Imray Correction Notice ICA30-2

Chart **A30** WGS 84

Edition 2018

21 Cul-de-Sac Marin (Plan D)

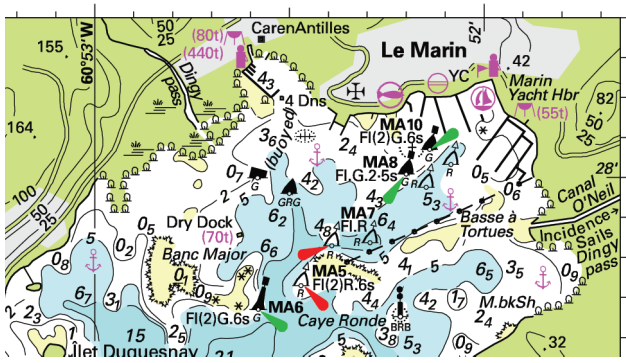
Insert restricted area, no anchoring, line joining:

14°28'·05N 60°52'·69W (coast)

14°27'·98N 60°52'·61W

14°27'·58N 60°53'·08W (Îlet Duquesnay)

and

14°27'·53N 60°53'·13W (Îlet Duquesnay)

14°27'·17N 60°53'·56W (Pte Petite Poterie)

Mooring is now prohibited in this area.

Delete anchorage sym. in:

14°27'·42N 60°53'·29W

14°27'·79N 60°53'·00W (ILNW 238/24)
